NEDO-24011-A, Revision 20,
General Electric Standard Application for Reactor Fuel
(GESTAR II, U.S. Supplement), October 2013

Licensing Topical Report

**General Electric Standard Application
for Reactor Fuel**

(Supplement for United States)

**Figure S-2. Loss-of-Coolant Accident Evaluation Model
(SAFER/GESTR Analysis Methods)**

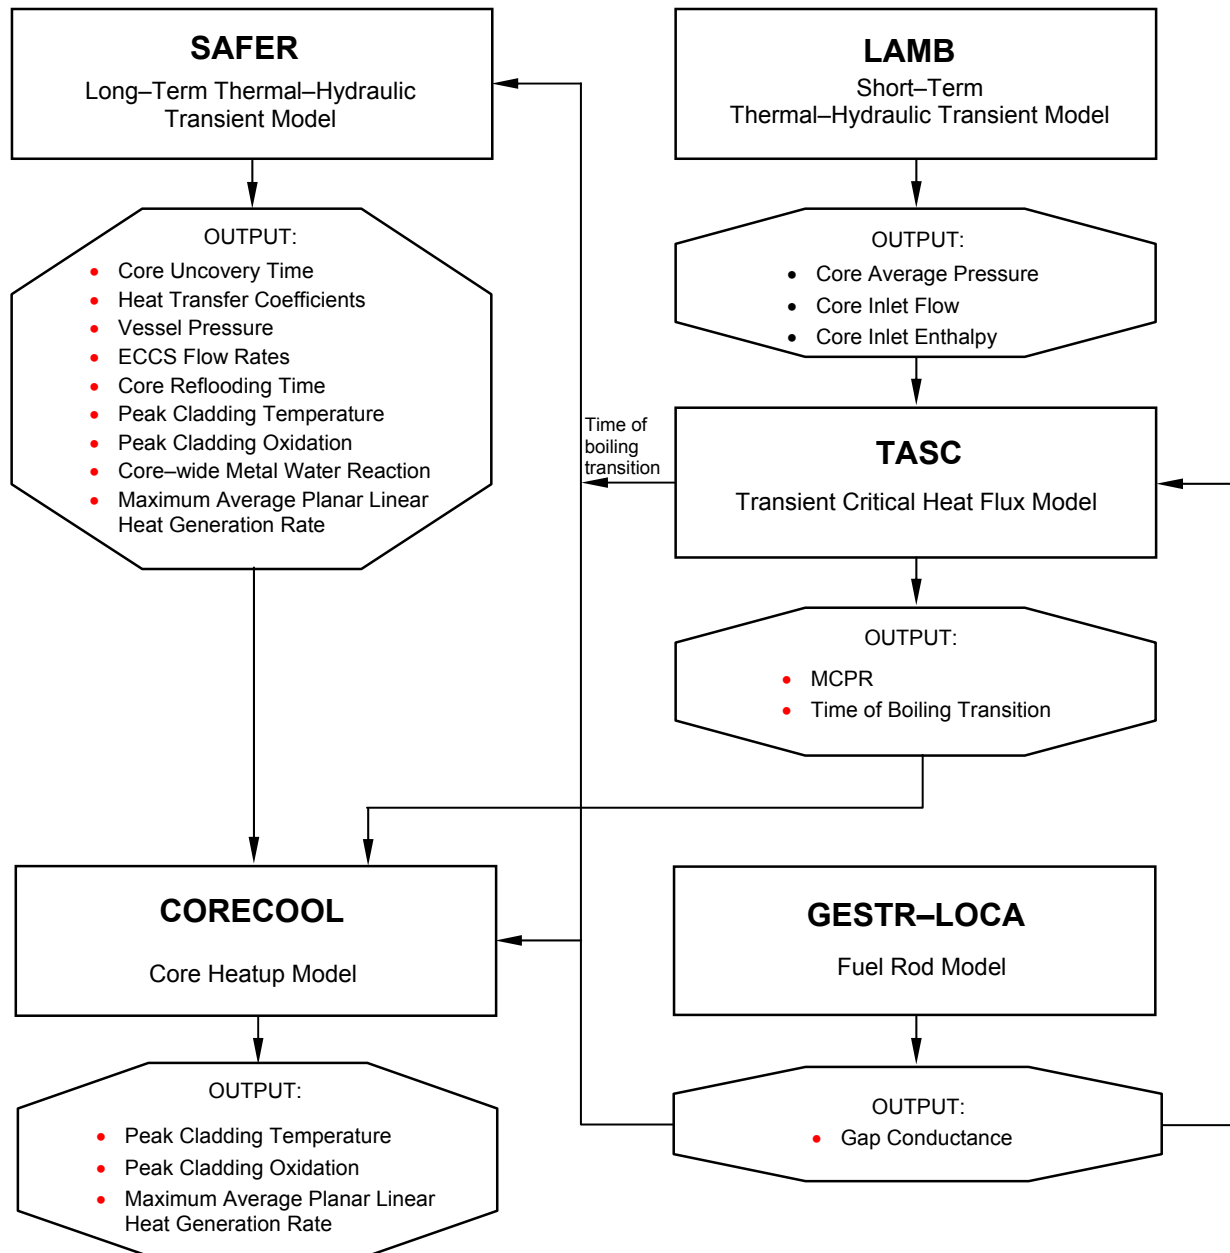
Correct Error in Figure S-2, "Loss-of-Coolant Accident Evaluation Model (SAFER/GESTR Analysis Methods)"

This figure has been updated to reflect the use of CORECOOL code instead of CHASTE for the core heatup model. The use of CORECOOL was approved in NEDC-30996P-A. This LTR has been previously reviewed and approved. The staff agrees that changing this reference in Figure S-2 is an administrative change and therefore is acceptable to the staff.

Figure S-3. Illustration of Scram and Controlled Entry Region Boundaries for BSP for Option III

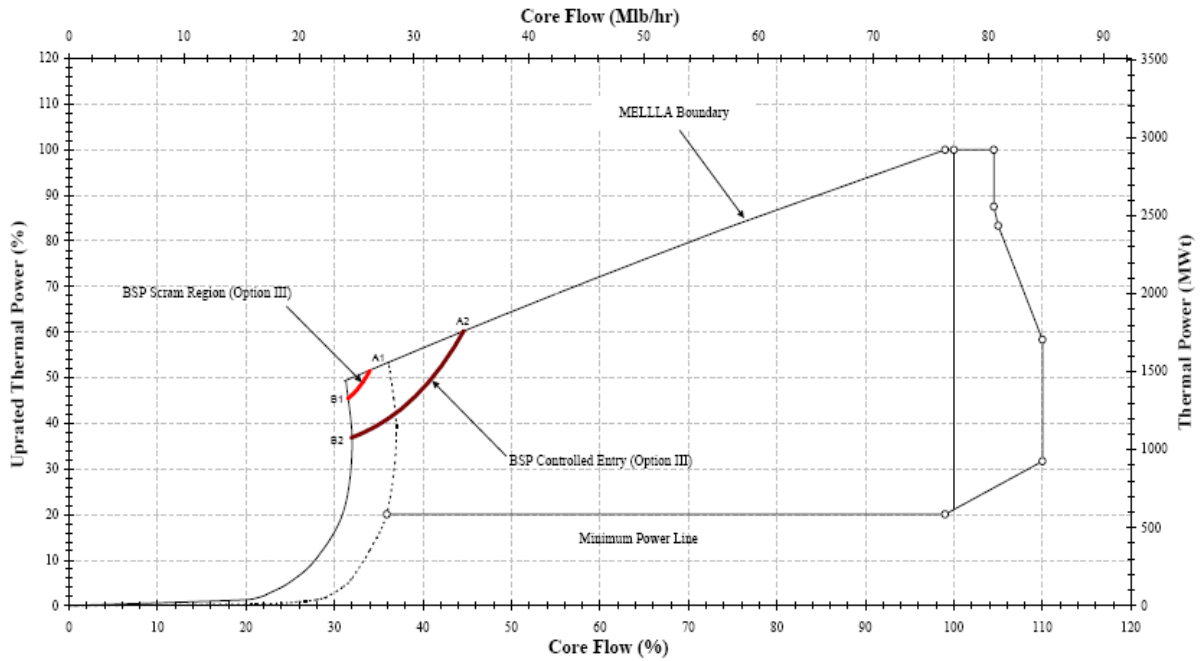
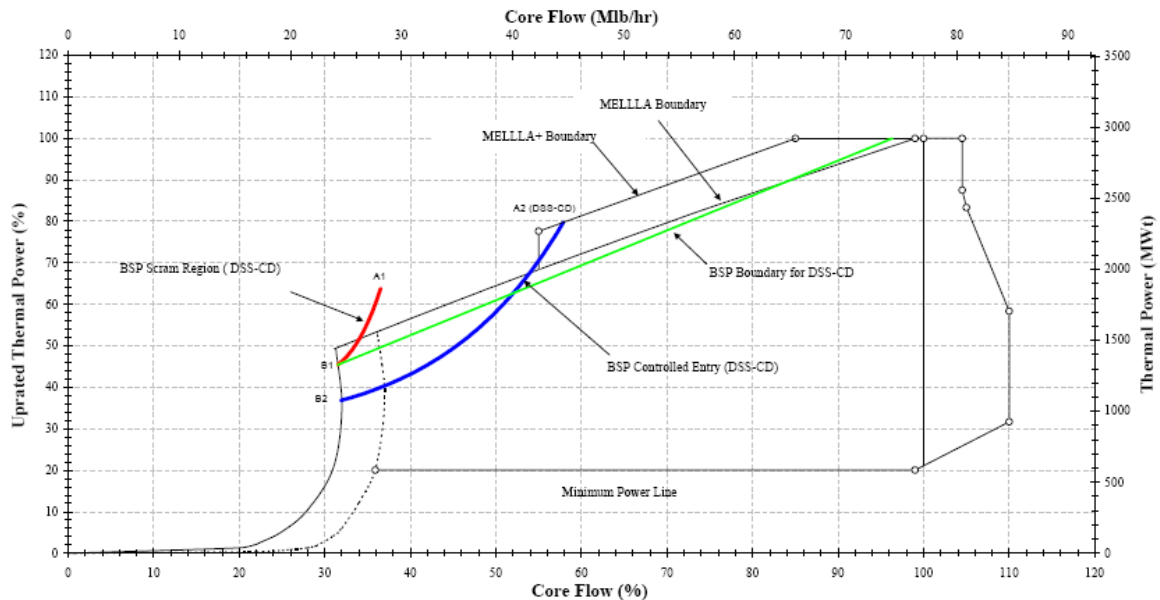
The BSP is required for an alternative interim prevention solution in case the Option III or DSS-CD solution is not operational. Therefore, the proposed change to add two new sections on BSP for Option III and DSS-CD with illustrations of the power/flow maps in Figure S-7 and Figure S-8, respectively, is acceptable.

Figure 5.2-1. Effects of Initial MCPR on Δ CPR Typical BWR Core

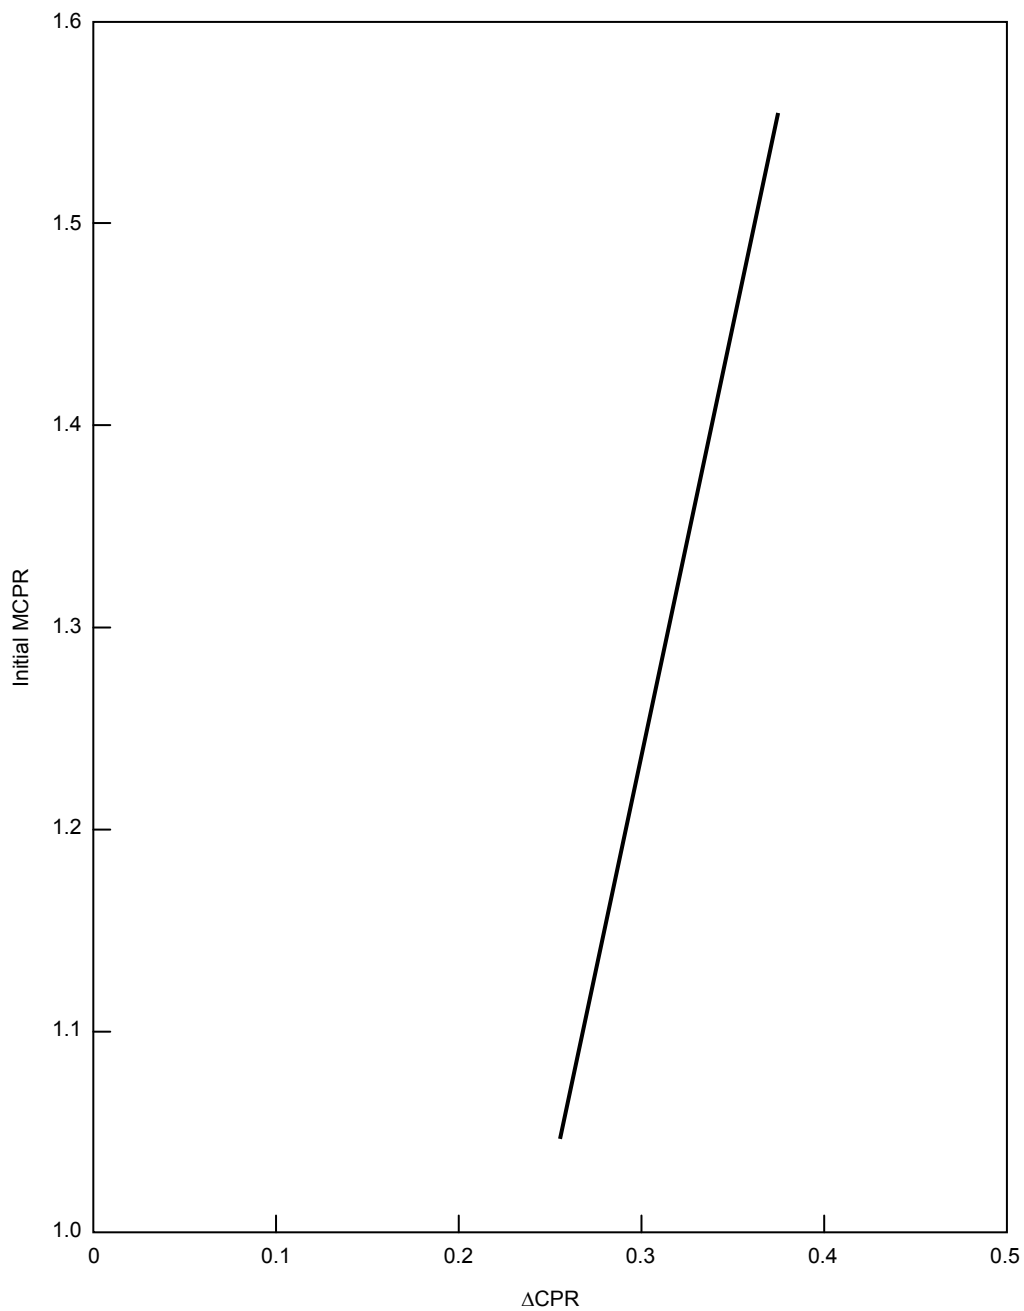
Based on Figure 5.2-1 in Appendix B on page US-6 under S.2.2.1, it appears that the change in ΔCPR versus initial MCPR may be 0.1 versus 0.5 not .01 versus 0.05. Please clarify that the statement is still valid when the change in ΔCPR is approximately 0.01 for 0.05 change in initial MCPR based on Figure 5.2-1 in Appendix B.

Figure 5.2-1 and the associated text in Appendix B of GESTAR II was generated to address an RAI on GESTAR II, Revision 5.

The specific response addressed the transient ΔCPR process and the initial MCPR assumption. Figure 5.2-1 and the discussion in GESTAR show the relative insensitivity of the ΔCPR to the initial MCPR assumption. This figure does indicate approximately a 0.01 change in ΔCPR for a 0.05 change in initial MCPR. The transient analysis process iterates the hot bundle power to achieve an initial MCPR such that the minimum CPR during the transient reaches the SLMCPR. In other words, the limiting transient could start at the OLMCPR and the minimum CPR would be the SLMCPR. Transients that are less severe have lower ΔCPR s, therefore, the initial MCPR in the transient needs to be lower for the transient minimum to reach the SLMCPR. The main point of the original response is to describe that starting non-limiting transients at a lower initial MCPR is acceptable because of the small impact to the ΔCPR . A non-limiting transient can begin the transient at a CPR less than the OLMCPR and have a minimum CPR above the SLMCPR.

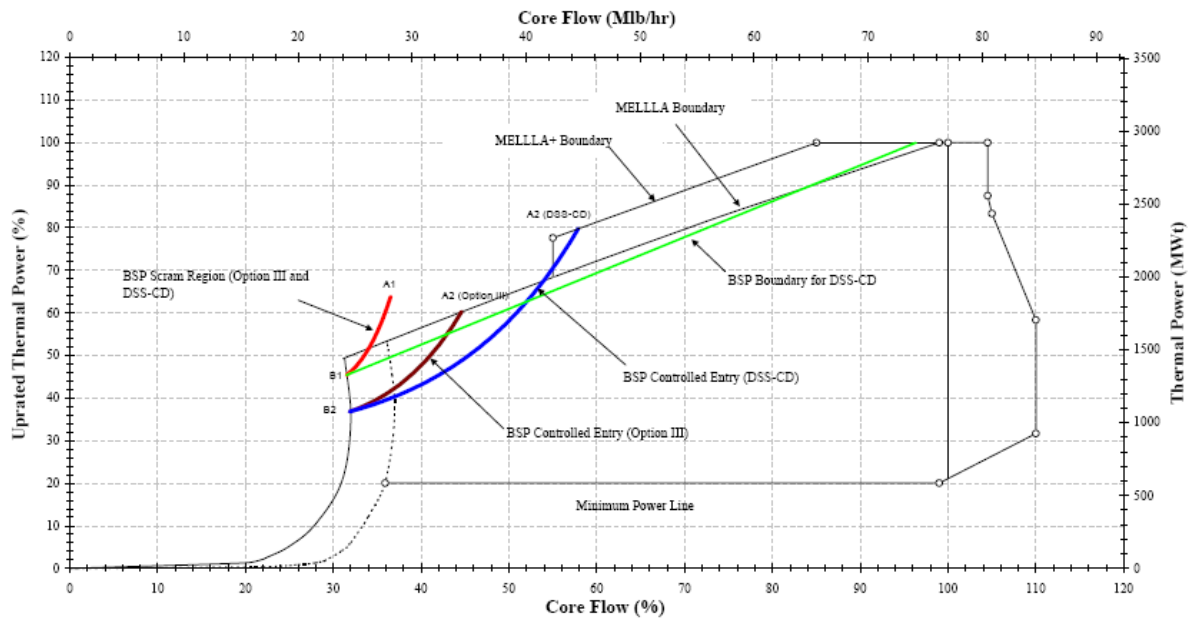
Please provide a power/flow map to show the difference of the domain for Backup Stability Protection (BSP) for DSS-CD under S.4.2.3 and Backup Stability Protection (BSP) for Option III under S.4.2.2, and describe what role Reference S-103 plays to generate a defined exclusion regions.

The calculated stability region boundaries for BSP for DSS-CD and BSP for Option III are shown in the figure below. Please note that the actual implemented BSP boundaries might be larger due to the Base BSP region definitions.

These two BSP methodologies are very similar between the two long-term stability solutions of Option III and DSS-CD. However, two differences exist:
